TANAKA et al.  
Appl. No. 10/656,325  
December 18, 2006

**AMENDMENTS TO THE DRAWINGS**

**REMARKS/ARGUMENTS**

FIG. 1

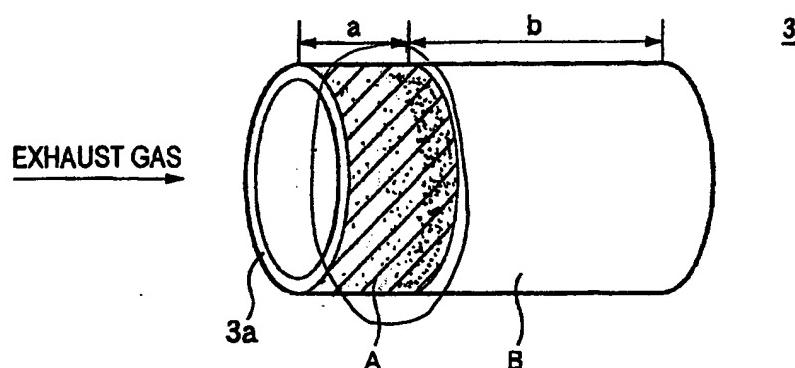
The attached sheet of drawings includes changes to Fig. 1. This sheet, which includes Figs. 1-3, replaces the original sheet including Figs. 1-3. In Figure 1, dots have been added to illustrate an exemplary feature of the invention.

The drawings were objected to as failing to comply with 37 C.F.R. §1.84(p)(5). The Office Action contends that reference character “b” is not mentioned in the description. To the contrary, however, reference character “b” is provided on page 6, line 138. Withdrawal of the objection is requested.
